SITE INSPECTION SHEET

ADDRESS: 12203 Etchison Rd. CONTRACTOR: \_\_\_\_\_

Subject: Percolation Certification Plan  
Woodmark, Lot 28 Section II, Block B, Csanady Property

FILE INQUIRY NOTES

LOCATION DIAGRAM

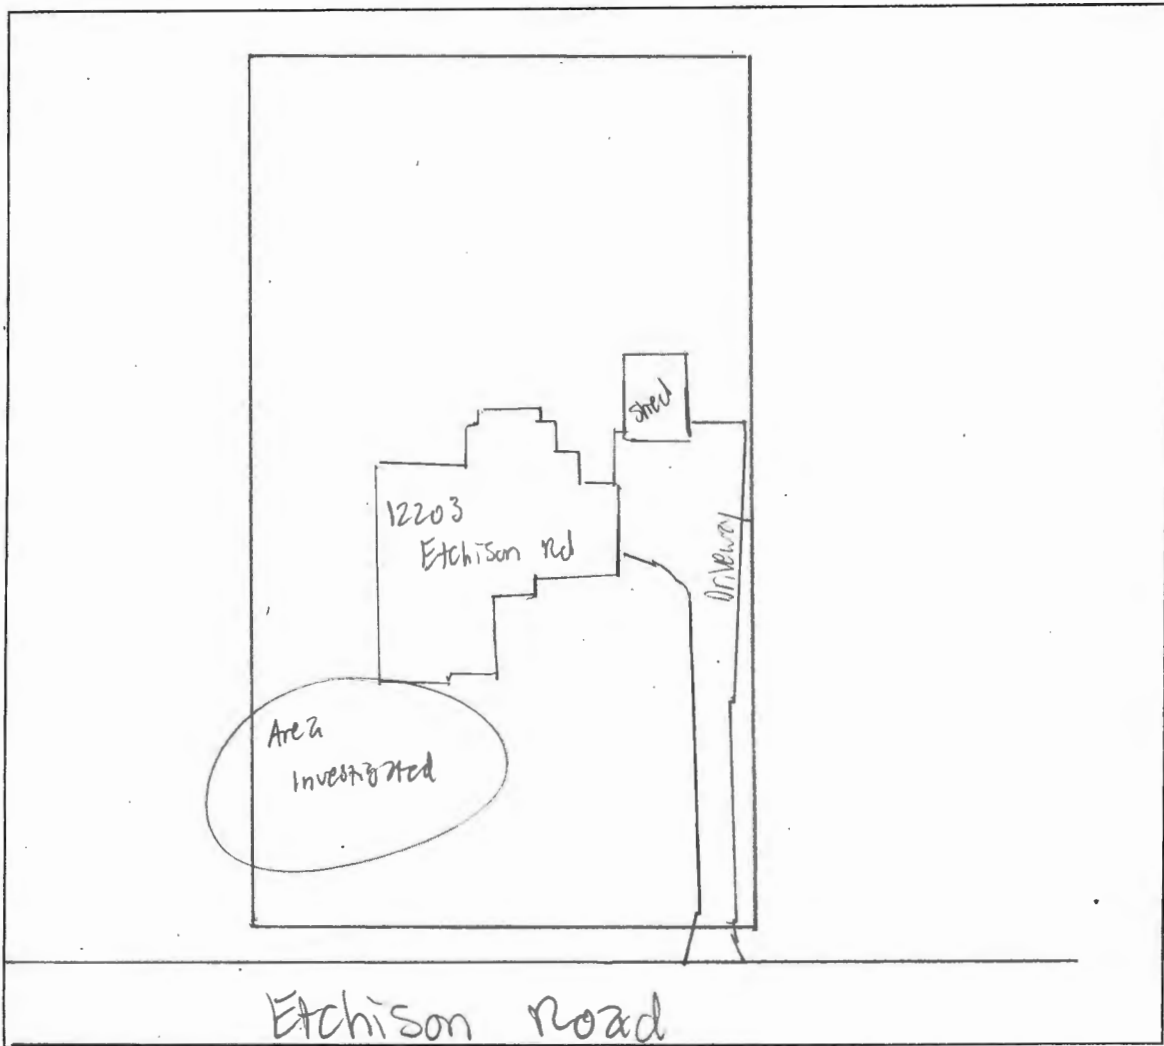
COMMENTS: On site to verify septic system functioning properly. spoke w/ homeowner & confirmed they're not having problems w/ sewage backing into the home & no sewage smell near drainfield. Walked around drainfield & saw/smelled no signs of a failing system. weather conditions were 45°, cloudy, & raining. (SP)

LOCATION DIAGRAM

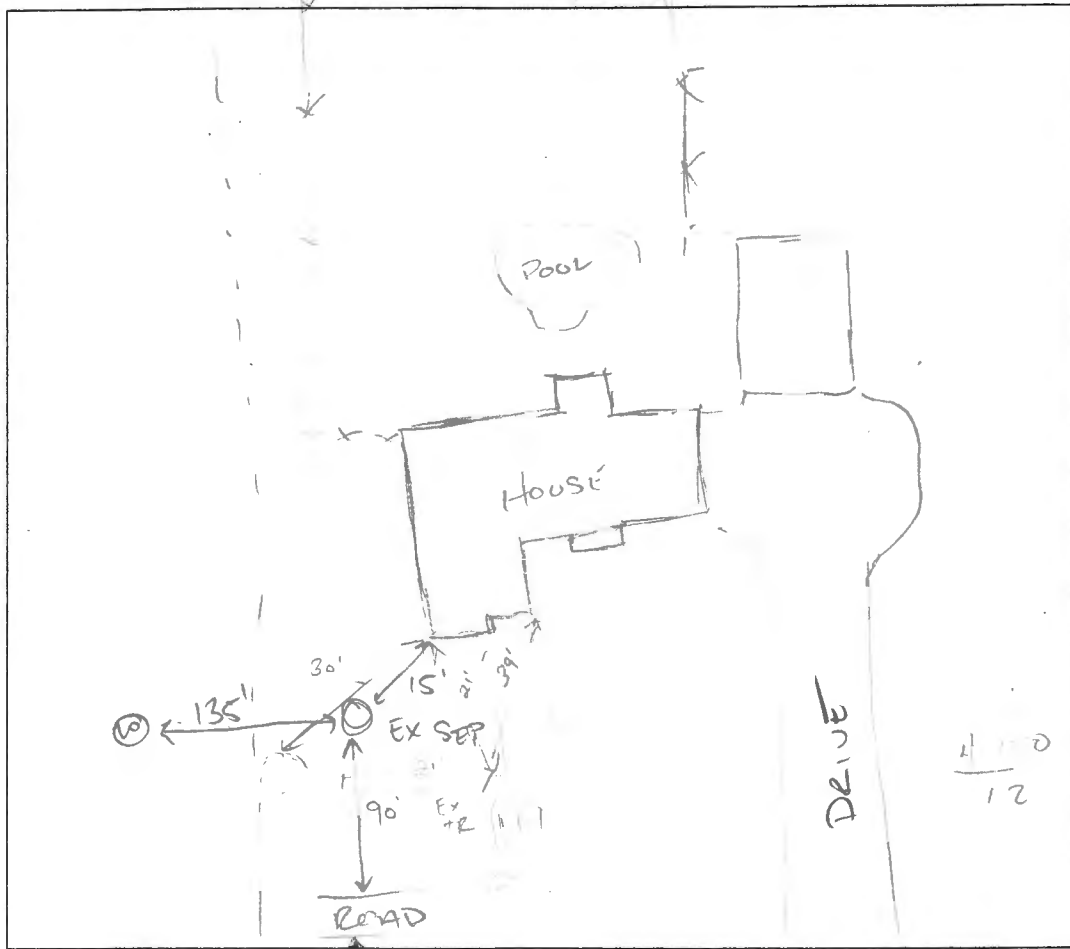
3  
 8' Bottom  
 5' ECH/ACC  
 < 100'

REPORTED SEPTIC FAIL.

11/24/2020 - SYSTEM IS STILL FUNCTIONING. EX DW IS FULL.  
 23' TRENCH IS STILL FUNCTIONING
